Commonwealth Edison
 One First National Plaza, Chicago, Illinois
 Address Reply to: Post Office Box 767
 Chicago, Illinois 60690

September 27, 1976

Subject: Dresden Station Units 2 and 3
 Quad-Cities Station Units 1 and 2
 NRC Docket Nos. 50-237, 50-249,
50-254, and 50-265

Response to NRC Questions Concerning LPCI/RHR
Pump Runout Situations

LOW PRESSURE CORE INJECTION SYSTEM

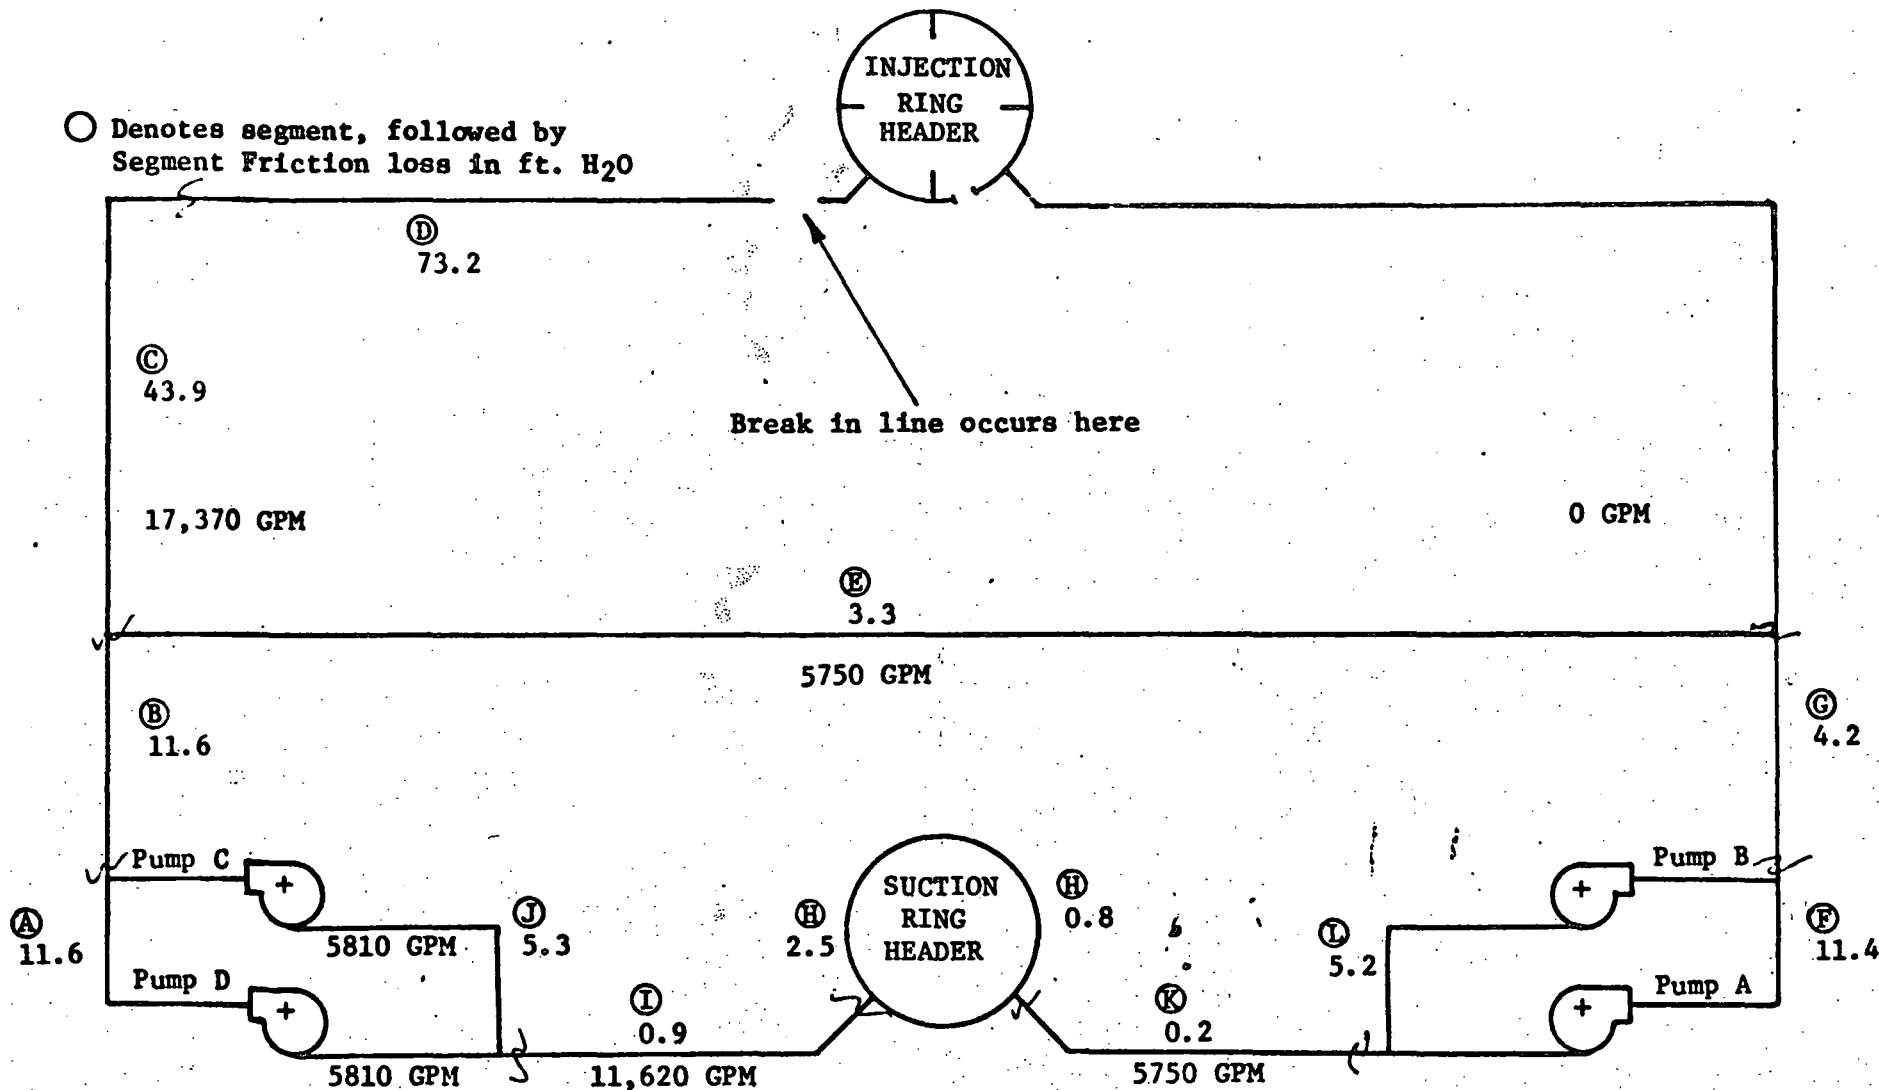
QUESTION 1
Calculation Method Description

The method used for calculations pertaining to the LPCI line break is described as follows.

The system in question is comprised of two-two pump systems. Due to the fact that the two systems have different system losses, and yet are interconnected systems, the two systems will have different operating points. In order to find the operating points it was necessary to solve three head loss versus flow equations written for different branches of the system. Incorporated into these equations was an equation that approximates the pumps head-capacity curve. Then an iteration process was used to solve the equations producing the systems operating points.

1. Total L/D for the torus ring header was divided equally to each suction loop. With 11620 gpm to the loop with two operating pumps and 5750 gpm to the loop with one operating pump, separate friction losses were calculated. An entrance and strainer loss of 1 foot was assumed for the two-pump loop and 0.25 feet for the loop with one operating pump. Total friction loss to the two-pump loop is 2.47 feet; total friction loss to the one-pump loop is 0.8 feet.
2. With pump centerline as reference, torus water level is 15.0 feet, Segment E is 20.0 feet, location of pipe line break is 50.0 feet and injection header is at elevation 67.0 feet.

- SYSTEM CONDITIONS:
- 1) Three pumps (A, C and D) injecting into two recirculation loops with one loop broken,
 - 2) Atmospheric pressure above the suppression pool and in the drywell,
 - 3) Torus water temperature of 130°F, 4) Vessel pressure of 56 psig,
 - 5) Suction ring header has one entrance strainer plugged, and
 - 6) Core spray pumps are drawing suction from suction ring header also.

FIGURE 5.2.17. SUPPRESSION POOL TEMPERATURE RESPONSE FOLLOWING DESIGN BASIS LOSS OF COOLANT ACCIDENT

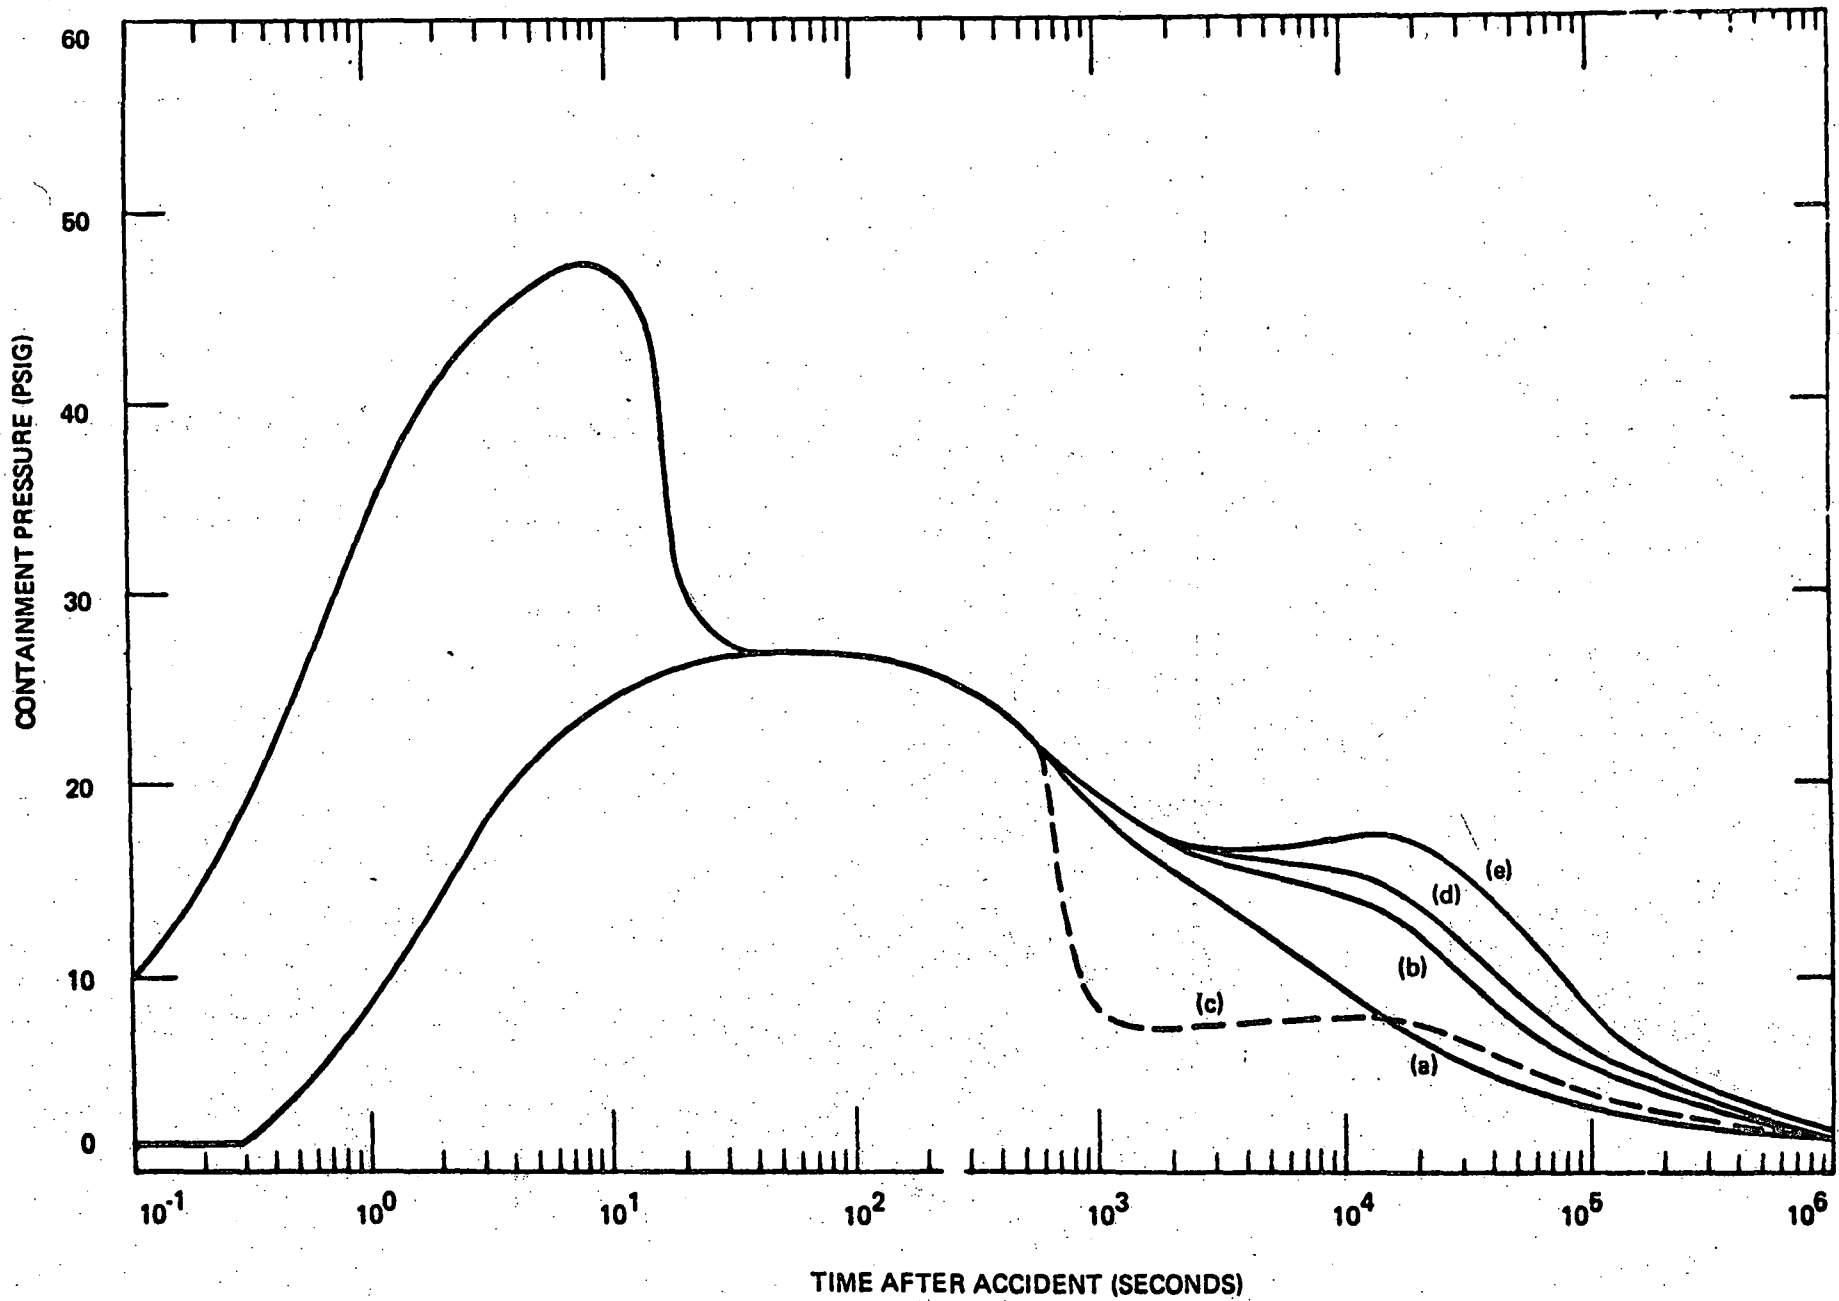
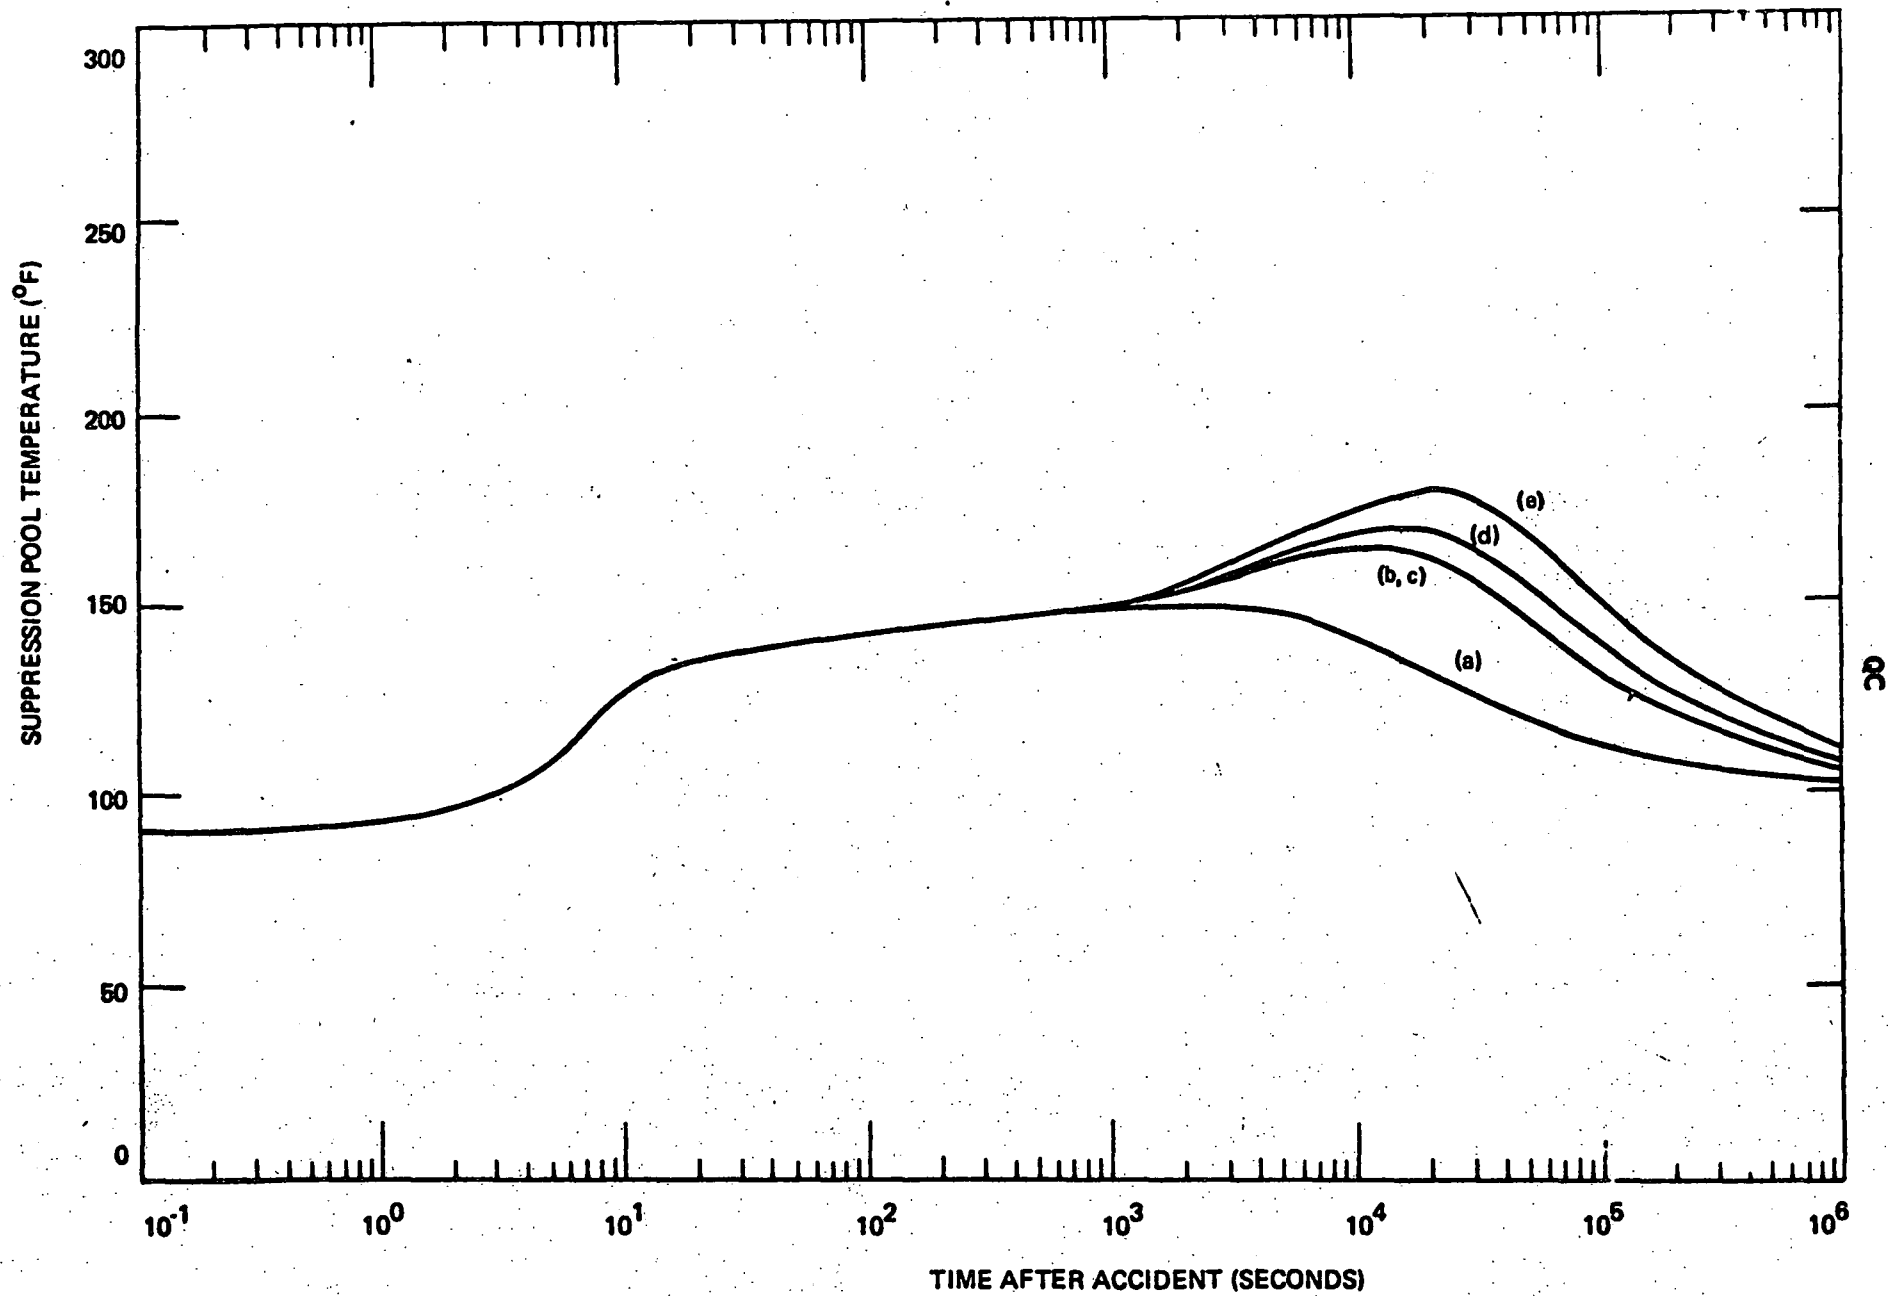
Question 2: For the case resulting in largest RNPSH minus ANPSH, describe the NPSH available as a function of time, both short-term and long-term, in the event of a postulated loss-of-coolant accident. Suppression pool temperatures versus time should be indicated, and the effect of pool temperature should be included in the calculation.

Although the details of suppression pool temperature as a function of time are not immediately available for Dresden Station, this information is included in the Quad Cities FSAR. The assumption is made herein that the Dresden plant is similar enough to Quad Cities that the Quad Cities analysis is approximately applicable to Dresden also.

The suppression pool temperature versus time for a postulated LOCA is illustrated by the attached figure 5.2.17 from the Quad Cities FSAR. Also attached is the corresponding containment pressure plot. These figures show that, while torus temperature reaches 130°F within about 2 minutes, containment pressure in a similar time period approaches 25 psig. The suppression pool temperature increase from 95°F causes mild decrease in available NPSH for suction on the torus due to the increased vapor pressure of the pool water. However, the associated pressure increase easily compensates for the temperature induced deficiency. Incorporating both the temperature and pressure effects in the NPSH calculations (this should not be in violation of appropriate Regulatory Guides, since credit for the pressure increase is not required to provide adequate cooling flow.) yields an available NPSH at equilibrium of about 91ft for the worst case (RNPSH for this case is 40ft). Consequently, adequate NPSH is available in even the worst case analyzed to insure that no danger to the pumps will occur.
